City of Woodburn
Community Development Dept.

Memorandum

Date: March 4, 2022
To: Dago Garcia, P.E., City Engineer
Cc: Chris Kerr, AICP, Community Development Director
Roy Hankins, PE, Emerio Design
From: Colin Cortes, AICP, CNU-A, Senior Planner *cc*
Subject: **Planning Division review comments on civil engineering plans 2nd / 1st revised submittal 2022 for Smith Creek Phase 3A (Tax Lot 052W130000105)**

New Item K: Sheet 51 street tree plan:

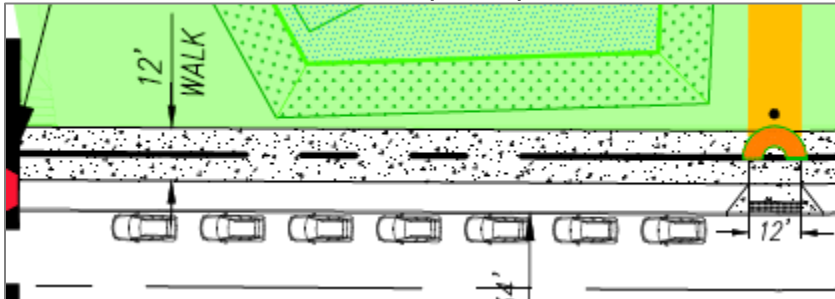
3. Condition PUD-9c2 is not met:

“Phase 3A: Gunderson Ave: The north/northwest side of Gunderson Avenue lacks a planter strip or tree wells, and common area is along much of this side. The developer shall plant 1 tree per 30 ft of frontage between Simon Street and Stubb Road. Placement shall be within 6 ft of the sidewalk. At least one tree shall be at the west side of each of the east mews east walkway and the west mews walkways that all intersect the sidewalk. The developer shall revise site plans accordingly.”

The block face width between the start of ROW curve at each of Stubb and Simon is 754 ft. Lessening out three public alleys each 20 ft width, $754 - 60 = 694$. $694 / 30 = 23.1 \rightarrow 23$ trees. The sheet illustrates 12; 11 are missing. Add 11.
